Amendments to the Drawings

FIG. 1

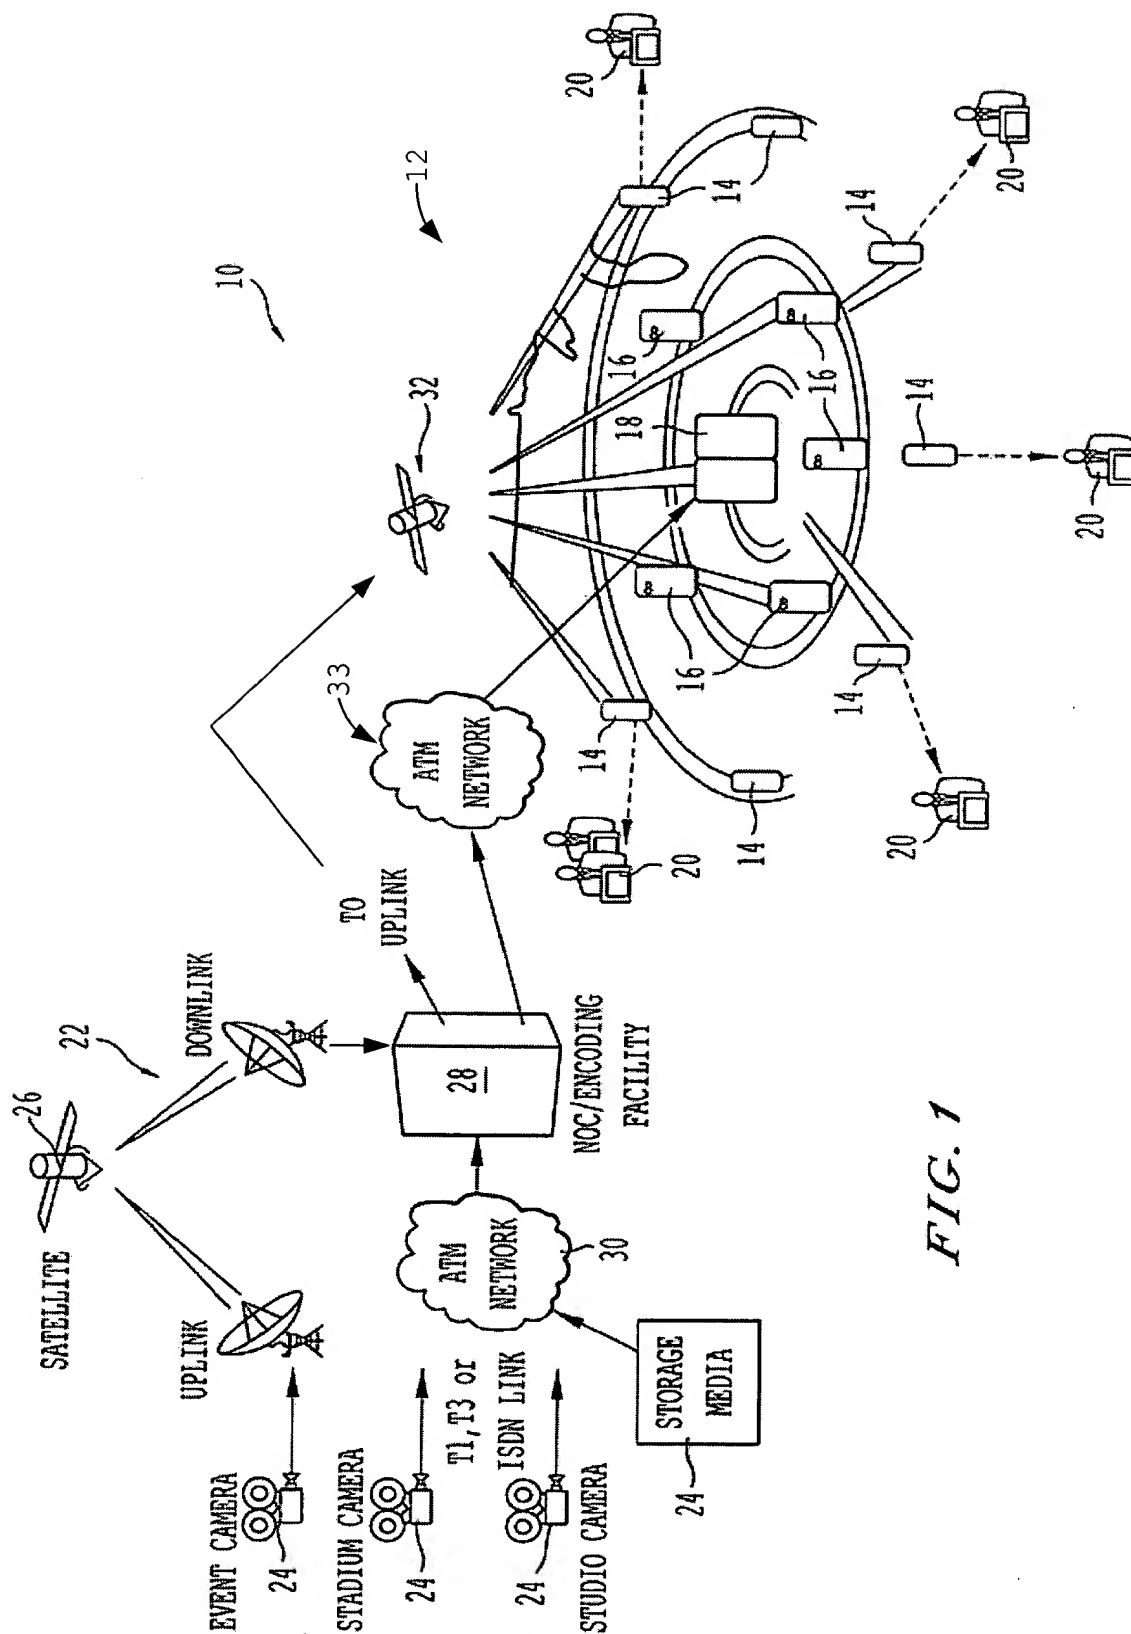
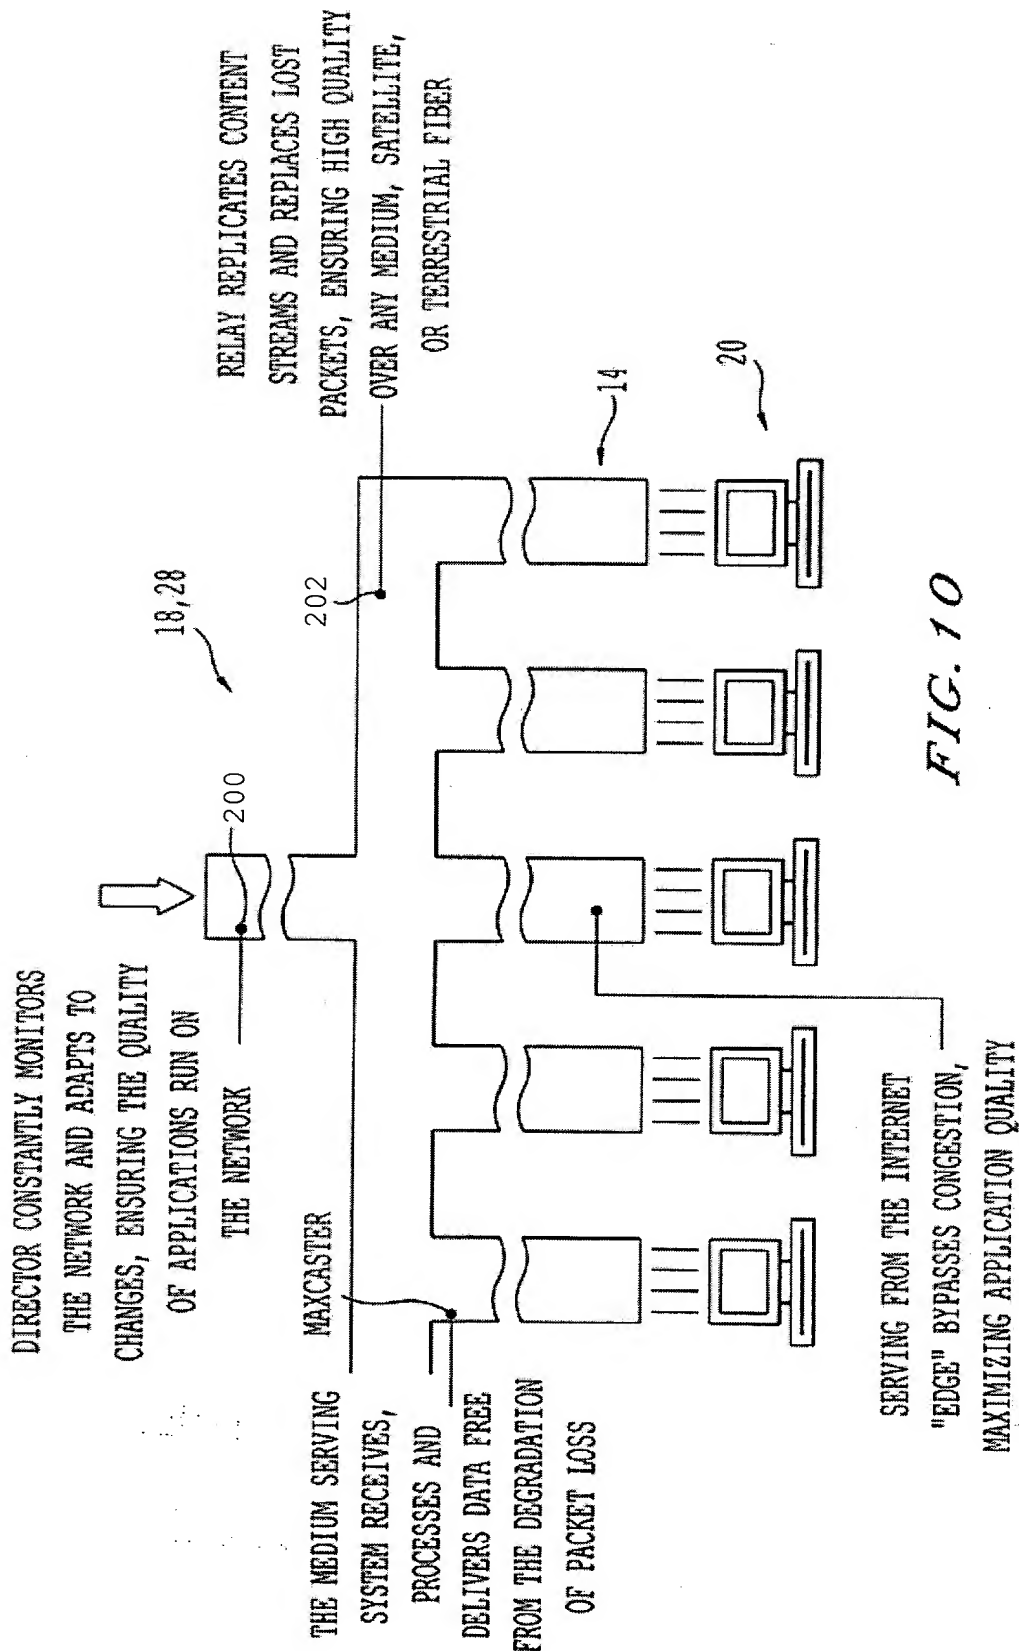
The attached sheets of drawings include changes to FIGS. 1, 10, and 11. These sheets, which include FIGS. 1, 10, and 11 replaces drawing sheets 1, 13, and 14, which shows FIGS. 1, 10, and 11. FIG. 1 of drawing sheet 1, has been amended to include sign number 12, and its associated lead line, identifying the distribution network; and sign number 33 has been added, and its associated lead line, identifying the ATM network. FIG. 1 also has been amended by adding an extended lead line between NOC 28 and Satellite 32; and adding data flow line between Downlink 22 and Uplink 28. FIG. 10 of drawing sheet 13, has been amended to replace “Director” with sign number 200, and to replace “Relay” with sign number 202. FIG. 11 of drawing sheet 14, has been amended to include sign number 12, and its associated lead line, identifying the network.
